APPLICATION FOR ZONING CHANGE

Date 2-25-91NAME OF PROPOSED DEVELOPMENT Steger Retail AdditionLOCATION OF PROPOSED DEVELOPMENT N.E. corner of FM 740 and
FM 3097NAME OF PROPERTY OWNER/DEVELOPER Estate of O.L. Steger, Jr. and Emily Sue
Whitehead
c/o Lakeside National BankADDRESS P.O. Box 9PHONE (214) 771-8311Rockwall, Texas 75087NAME OF LAND PLANNER/ENGINEER Winkelmann & Associates, Inc.ADDRESS 12800 Hillcrest Road, Suite 200PHONE (214) 490-7090Dallas, Texas 75230TOTAL ACREAGE 4±CURRENT ZONING ANUMBER OF LOTS/UNITS 1PROPOSED USE FOR DEVELOPMENT Grocery Store

FOOD LION, INC. SITE #50a
F.M. 740 @ F.M. 3097
Rockwall County
Rockwall, Texas

JOB NO.	06416.01
DATE	2-18-91
DRAWN	A.J.L./A.L.C.
CHK.	M.D.C.
DISC.	6416Site.Dwg
SHEET OF	1 of 1
SITE PLAN

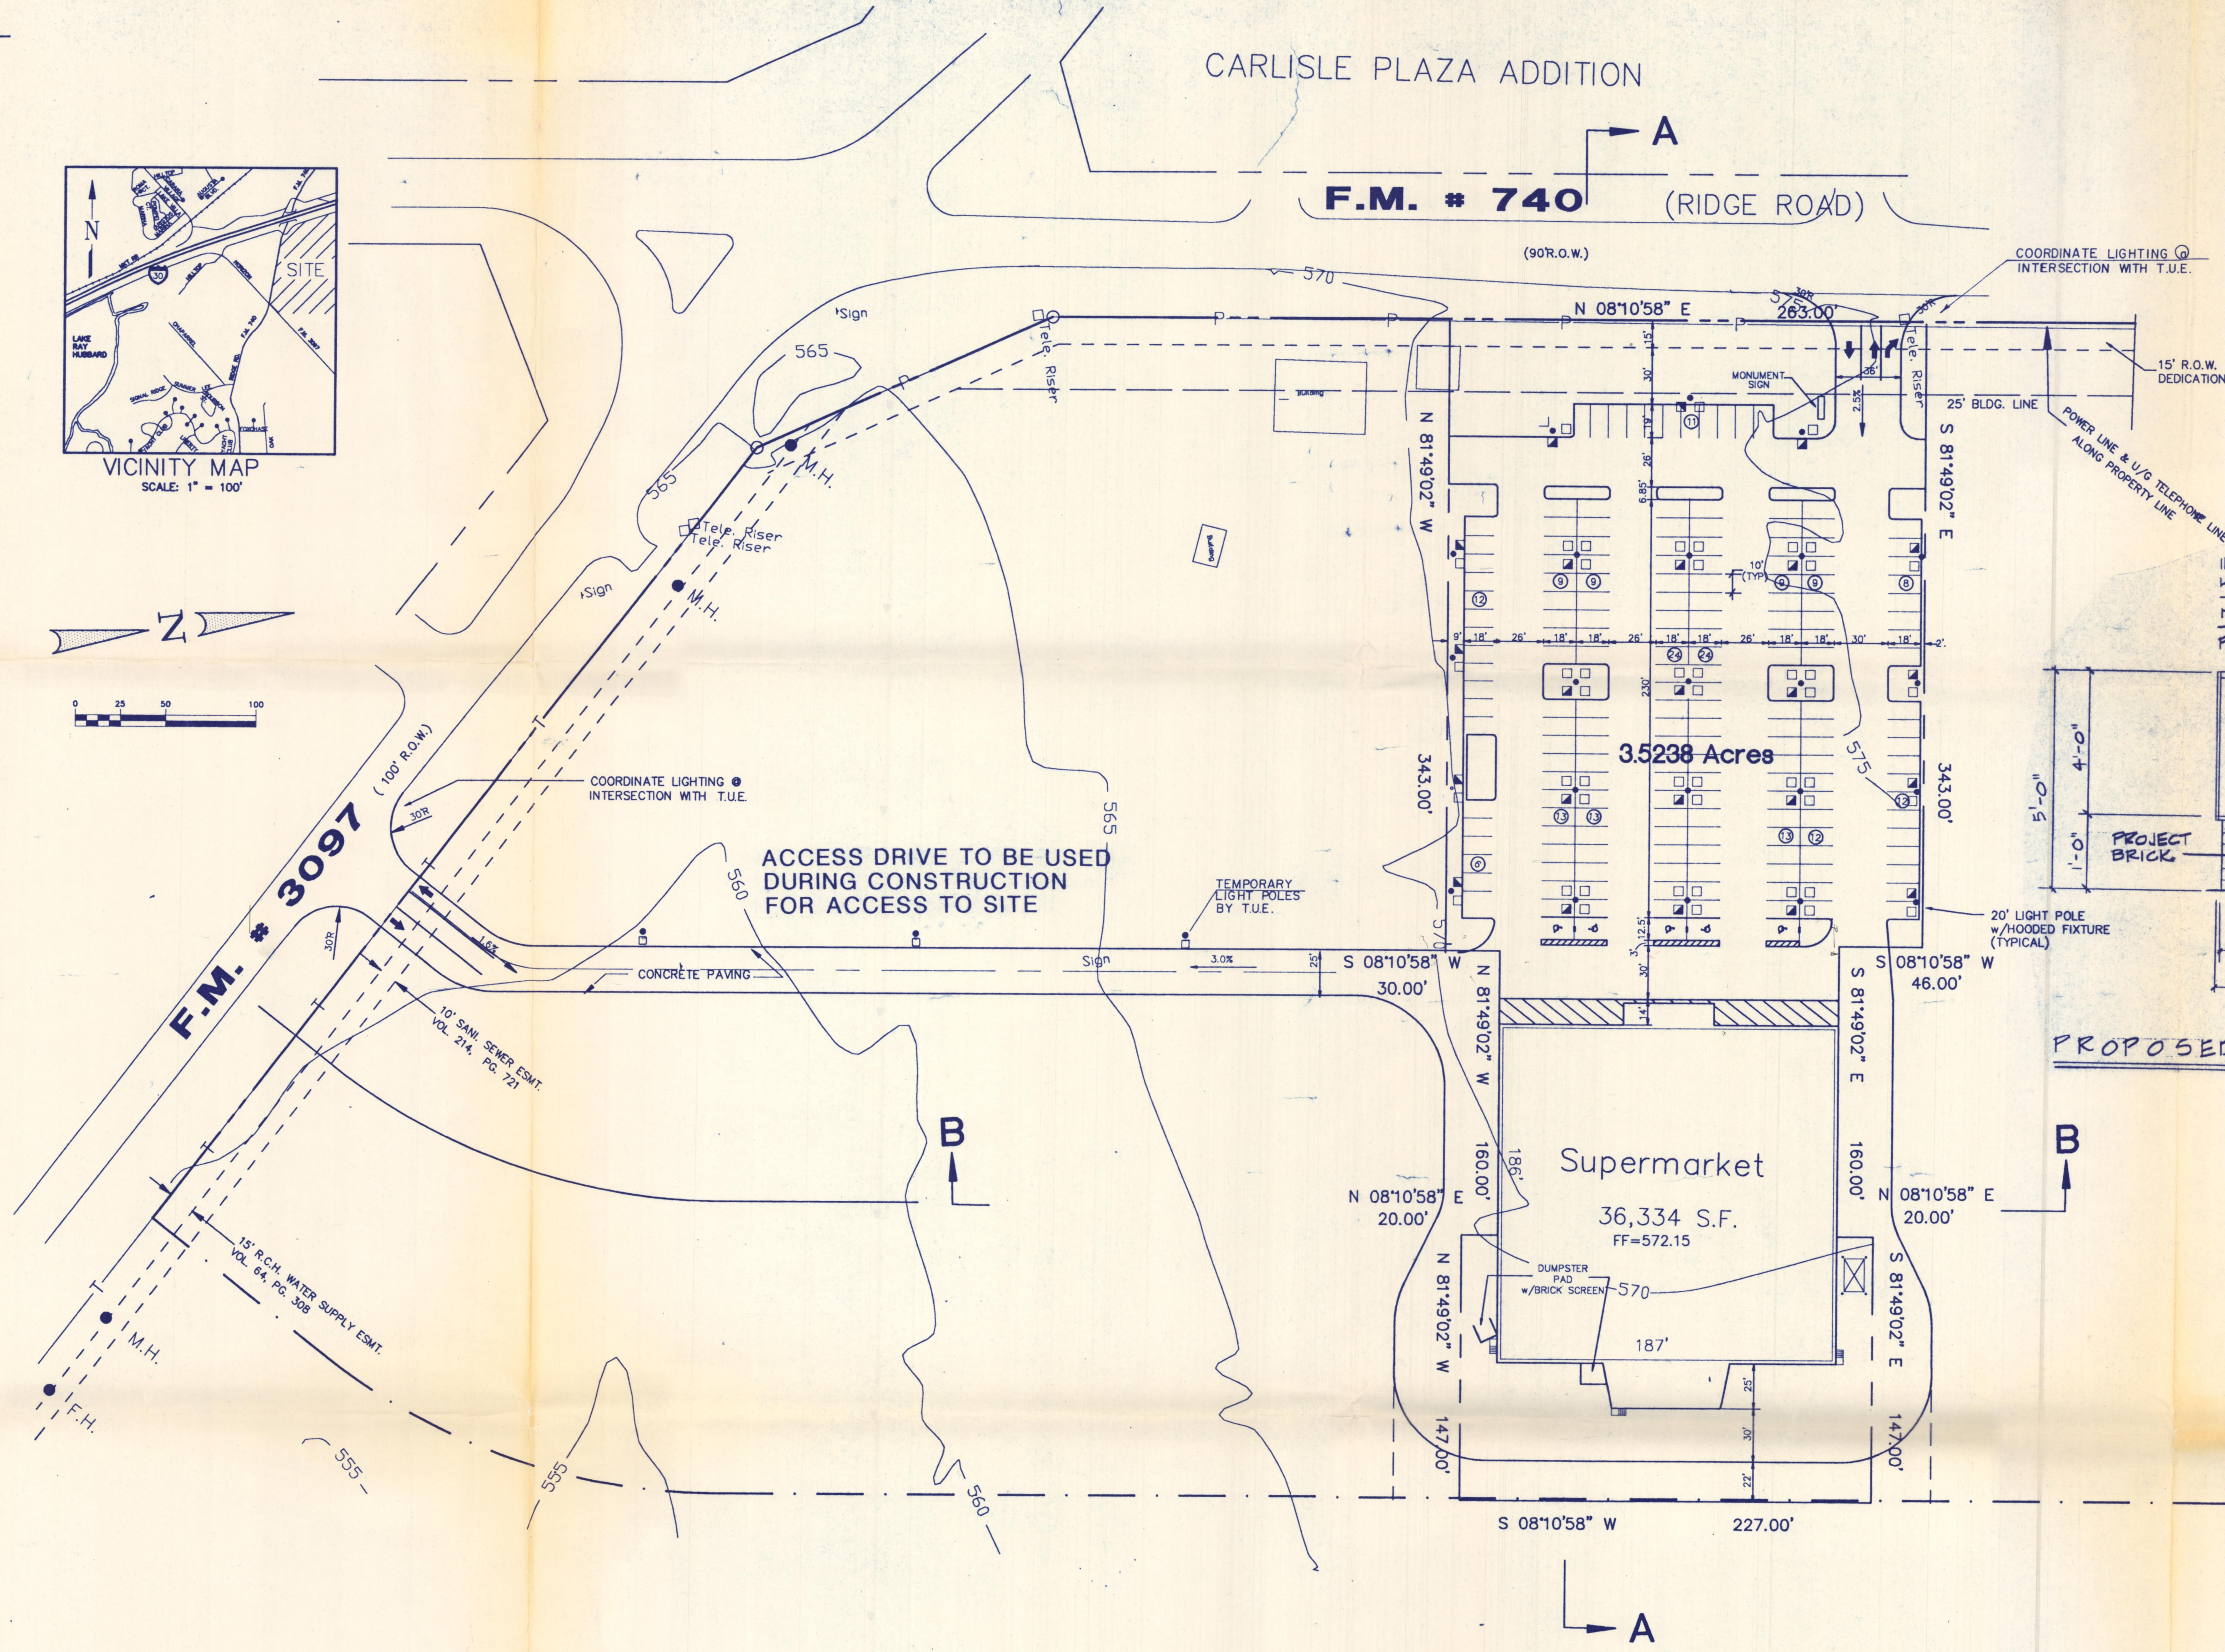
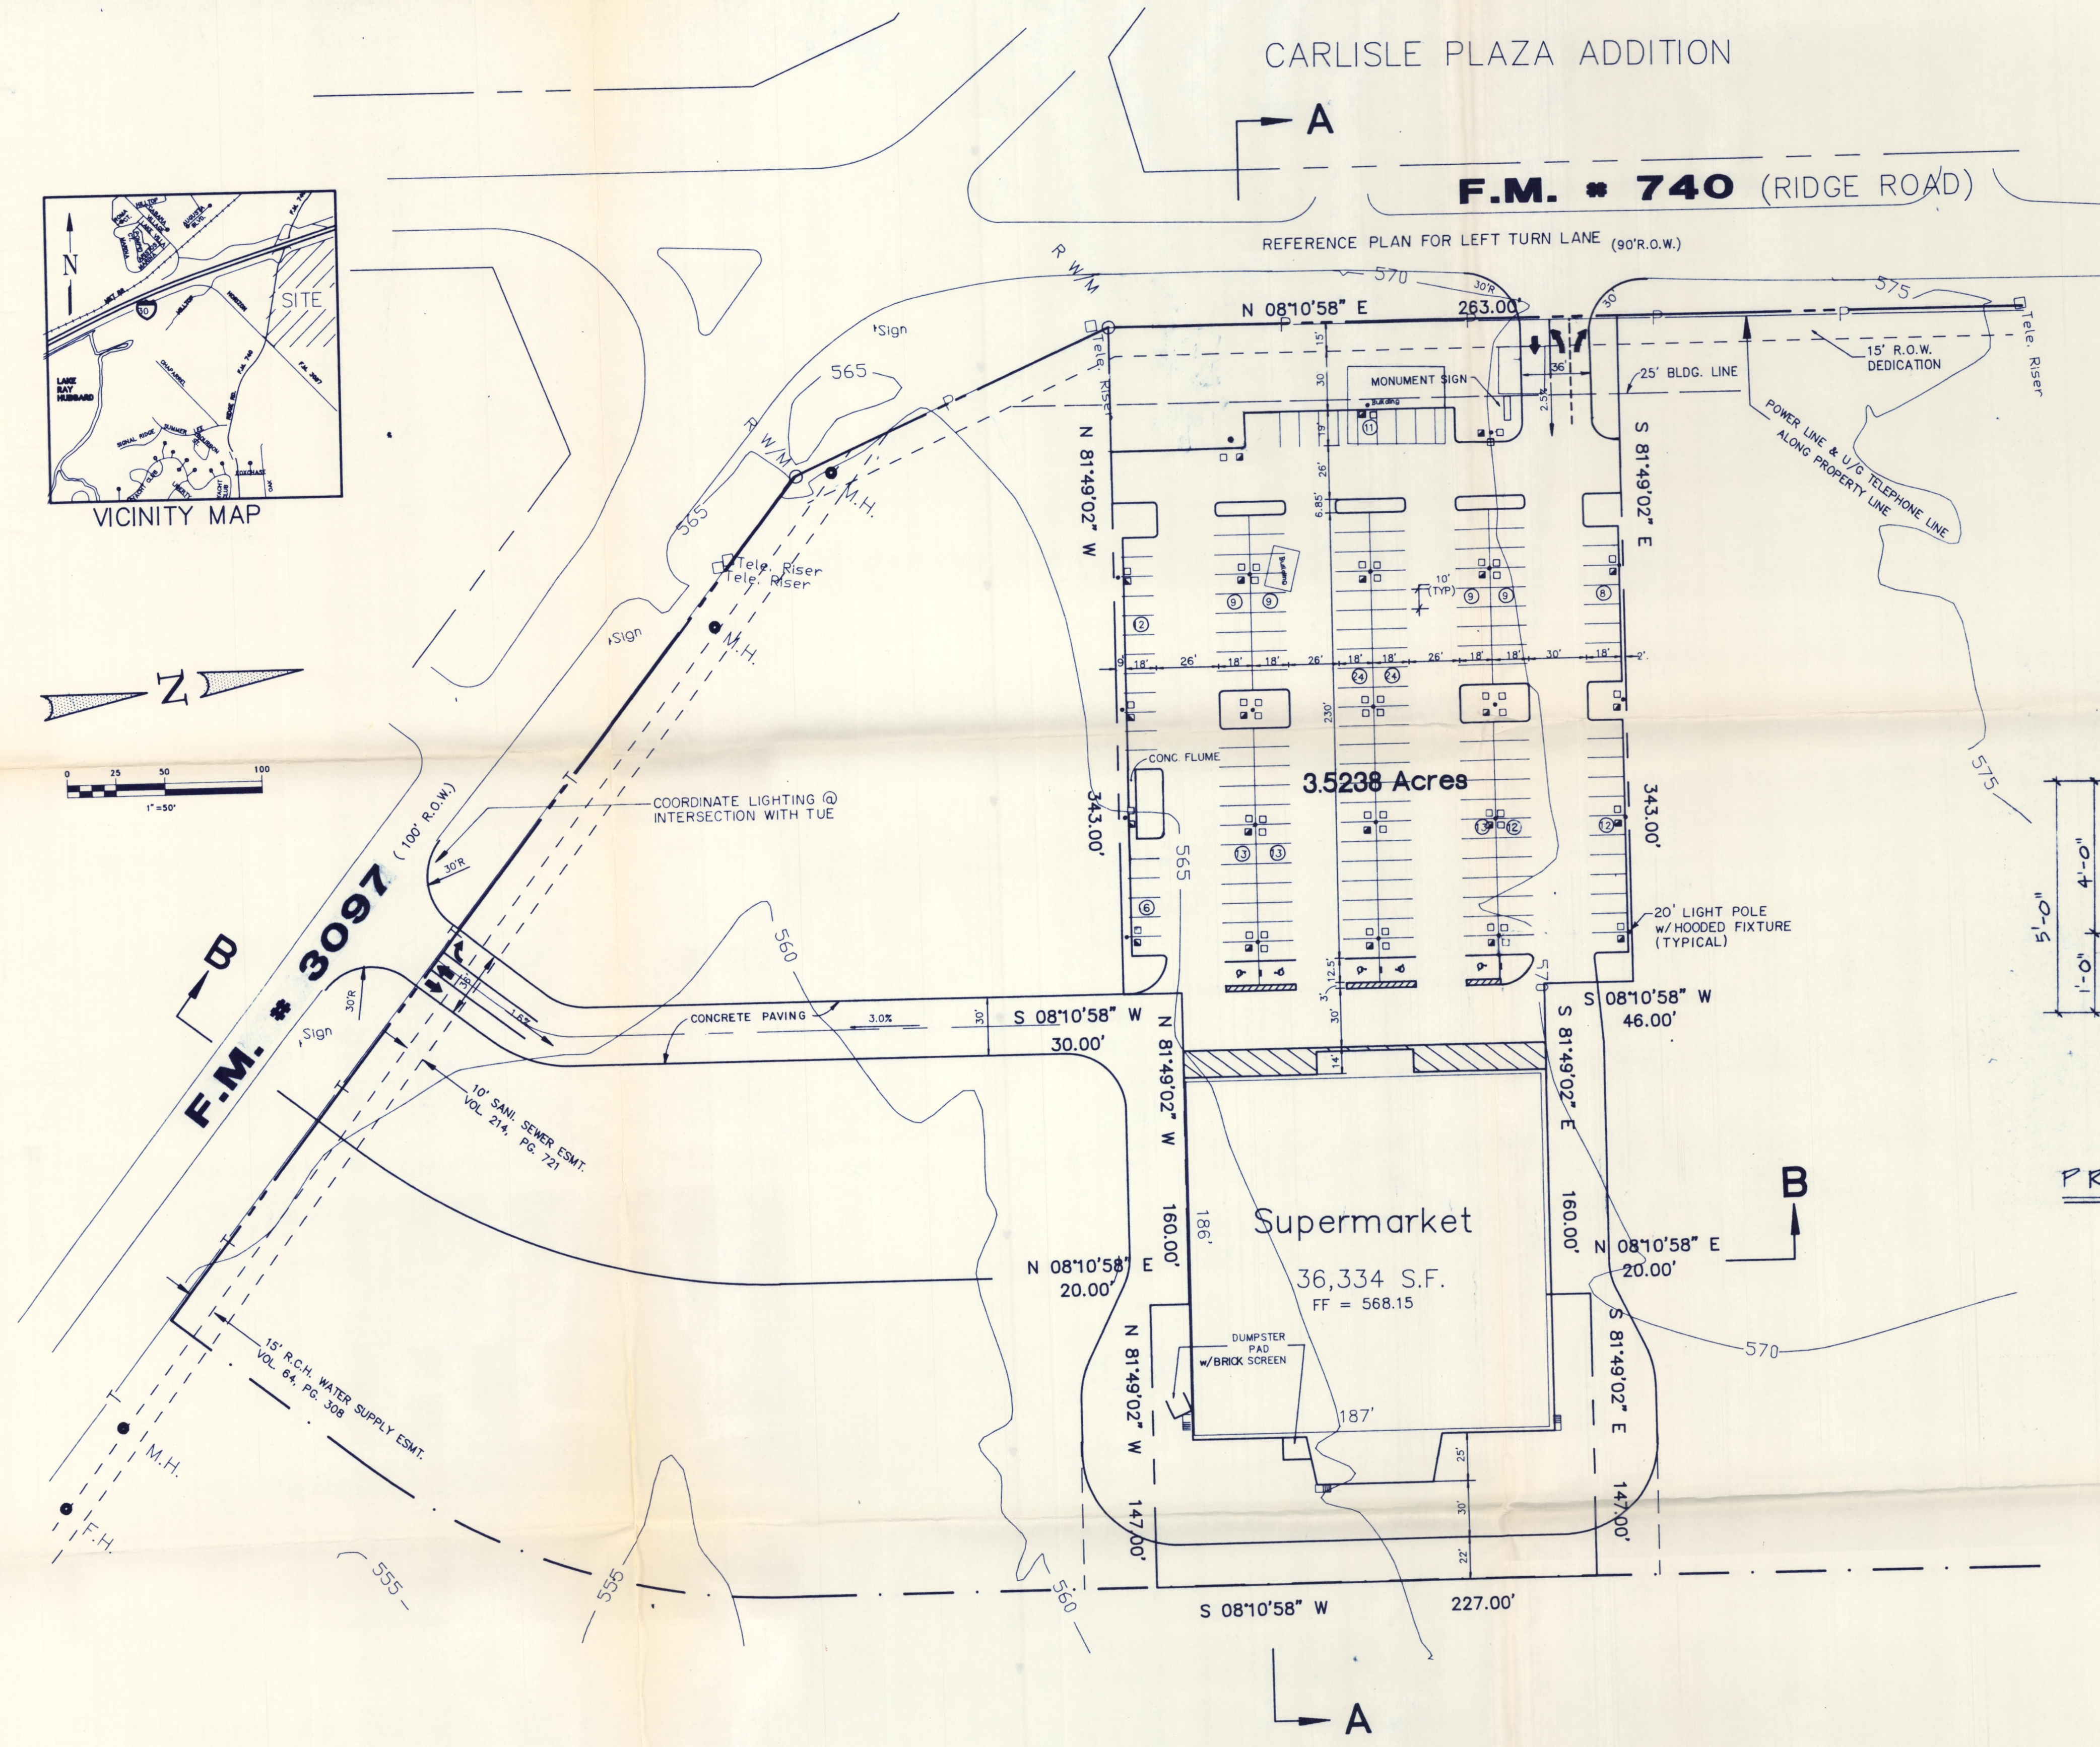
Approved copy
need to change landscaping

Site Plan

1. The plan proposes two drives on FM-740 that are approximately 160 feet apart. The minimum separation for drives along an arterial is 200 feet. The Commission

and Council have the ability to waive this requirement if it is determined to be in the interest of the City. The Commission and staff have some concern about the proximity of the southern drive to FM-3097. Given this concern and the fact that the drives do not meet separation standards you will need to either amend the plan to eliminate the southern drive or present your reasons for wanting the two drives. The original plan proposed for Food Lion to the south of this location did not propose two drives on FM-740.

3. There was some concern about the throat length of the entrance(s). I am having John Reglin review this issue.
4. As you are aware a turn lane does need to be provided for the entrance off of FM-740. From preliminary discussions with Mr. Reglin it appears that the existing turn lane for the shopping center can be added onto to meet the needs of your turn lane. You need to submit a schematic of what you propose to do to address the turn lane.

5. You need to submit details for the parking lot lighting. The previous site plan was restricted to light poles not exceeding 20 feet in height with hooded fixtures to direct the glare. Please indicate the type and height of lighting proposed.

SITE PLAN
